ACCESS REPORT

AMOEBA ACCESS PTY LTD

Project: Worth Street – Mixed Use
Document Type: DA Assessment Report
Our Reference: P2024_1604-4(DA) YW & DC

Figure 4 – Proposed continuous accessible pedestrian access route

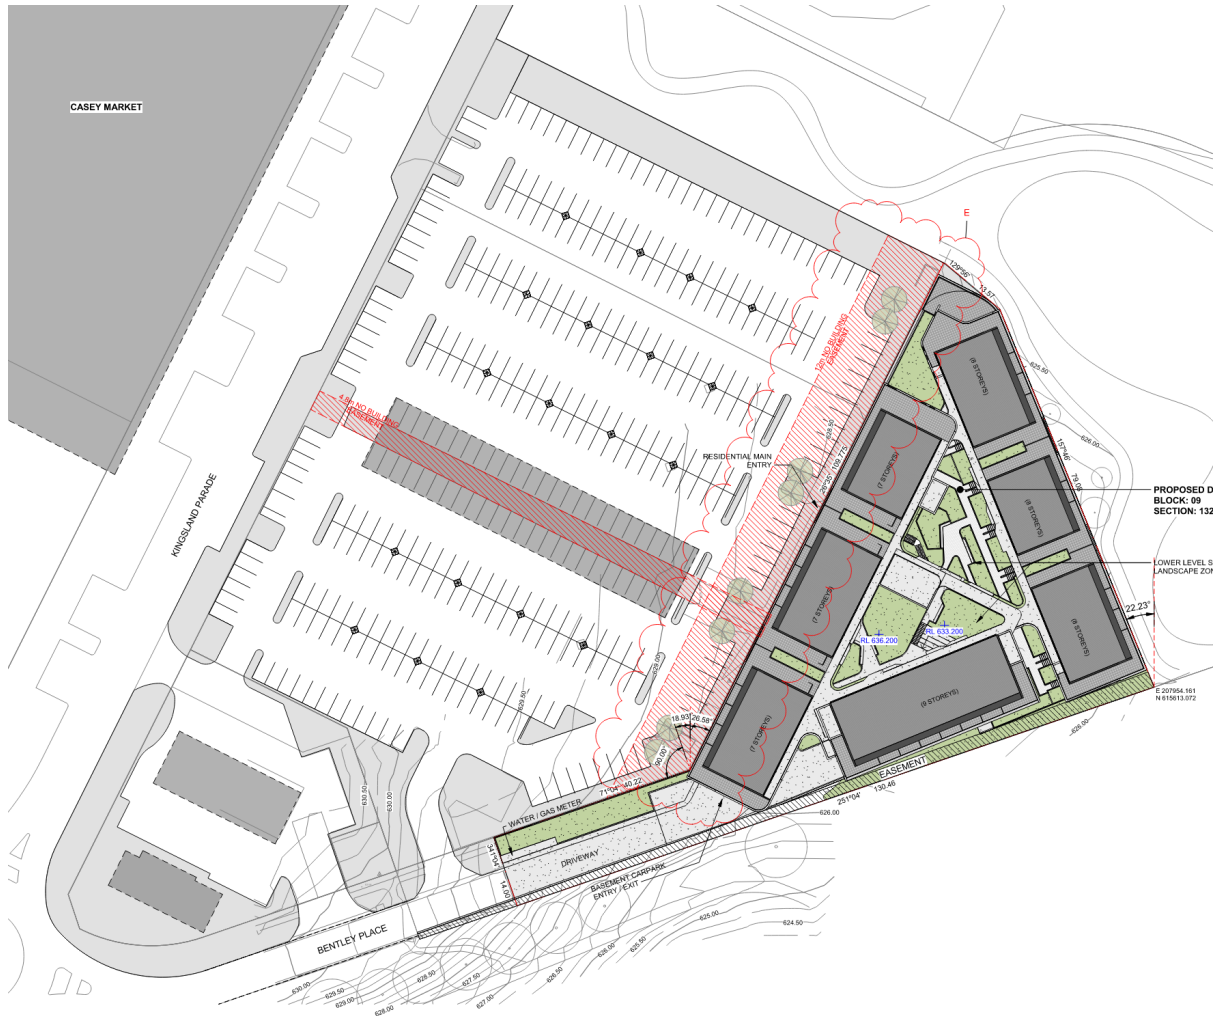
There are two pedestrian access points to the development site: one is via Bentley Place, and the other connects Kingsland Parade to the northwest entrance of the development site via a new pedestrian accessway (as indicated by the red hatched area). Both pedestrian pathways provide direct access to the existing on grade parking and commercial premises, connecting to the upper ground level entry lobby A (as illustrated below).

At the current stage of the design development, it is unclear as to how the existing public council footpath merges with the new pedestrian entries of the development in regards to levels. Details are to be addressed as the development progresses to Building Approval stage noting that 1:20 gradient and crossfall of 1:40 shall be achieved.
